| APPLICATION NO. | FILING DATE | FIRST NAMED INVENTOR | ATTORNEY DOCKET NO. | CONFIRMATION NO. |
|-----------------|-------------|----------------------|---------------------|------------------|
| 10/627,758 | 07/28/2003 | Didier Martin | 033818-007 | 4423 |

Office Action Summary

NEW SHEET
Appln. Filing Date: July 28, 2003
Title: TREAD WHICH REDUCES RUNNING NOISE
Inventor(s): Didier Martin et al.
Appln. No.: 10/627,758

FIG. 5

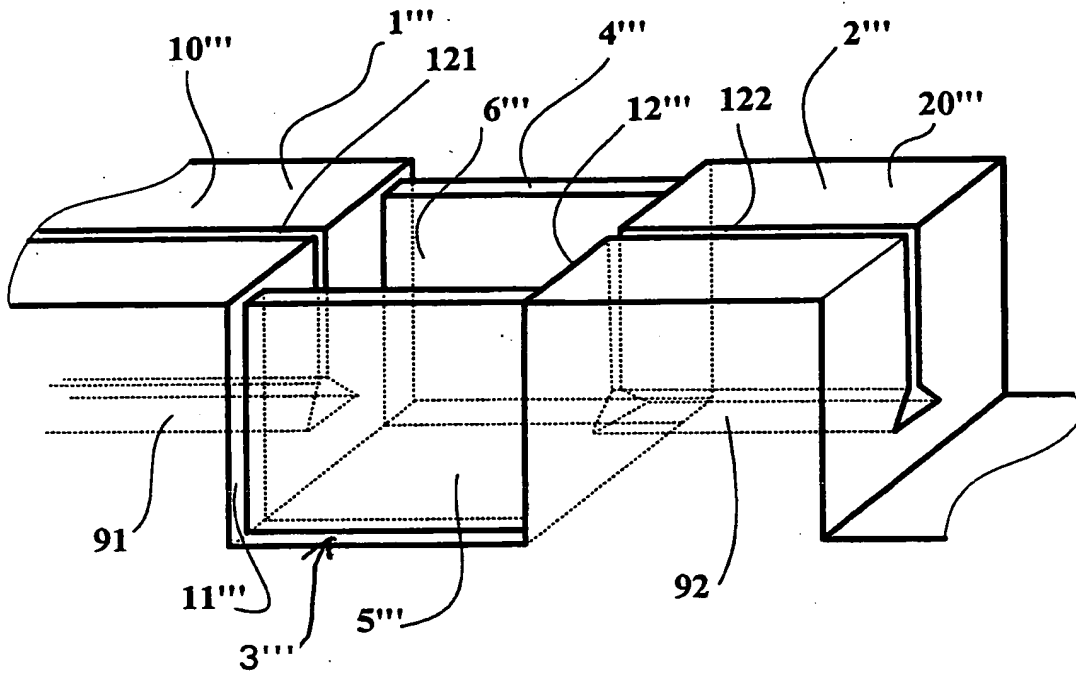
- 1) The proposed drawing correction for figure 5 filed 7-21-05 has not been approved by the examiner and accordingly has not been entered since the specification fails to describe 3".
- 2) The proposed drawing correction for figure 6 filed 7-21-05 has not been approved by the examiner and accordingly has not been entered. Reference numeral 51" in new figure 6 is not described in the specification. Also, see next paragraph in this office action.
- 3) The amendment filed 7-21-05 is objected to under 35 U.S.C. 132(a) because it introduces new matter into the disclosure. 35 U.S.C. 132(a) states that no amendment shall introduce new matter into the disclosure of the invention. The added material which is not supported by the original disclosure is as follows:

DO NOT ENTER
Jm 10-3-05

FIG. 6

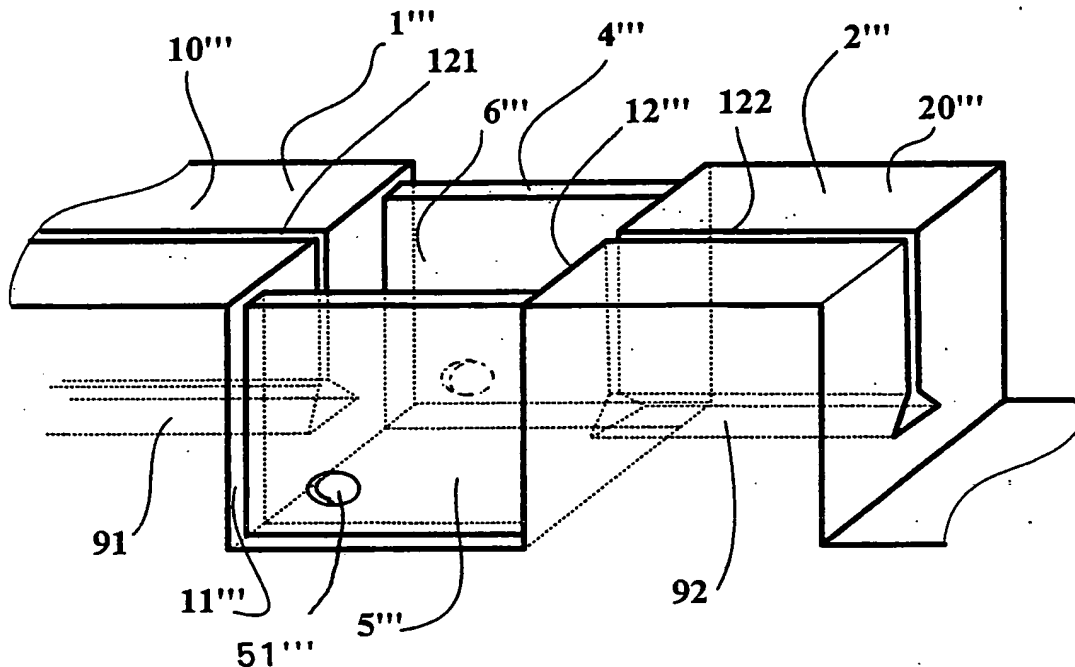
The new matter is new figure 6. Although the original disclosure describes combining a channel in the motifs and orifices in the connecting elements (page 8 lines 1-2), the original disclosure fails to reasonably convey the specific shape, number and location for the orifice as shown in new figure 6.

With respect to the drawings filed 7-21-05, new figure 6 has not been approved by the examiner and has not been entered. See MPEP 608.02(x), page 600-110, Rev. 2, May 2004 ("Where the corrected or changed drawings is not accepted, for example, because the submitted corrections or changes ... involve new mater ... applicant will be notified and informed of any corrected action in the next office action" and MPEP 608.04, page 600-112, Rev. 2, May 2004 ("a 'new matter' amendment of the drawing is ordinarily not entered ..."))

(2) The disclosure describes new figure 6, which as noted above, has not been entered.

DO NOT ENTER

Applicant is required to cancel the new matter in the reply to this Office Action.
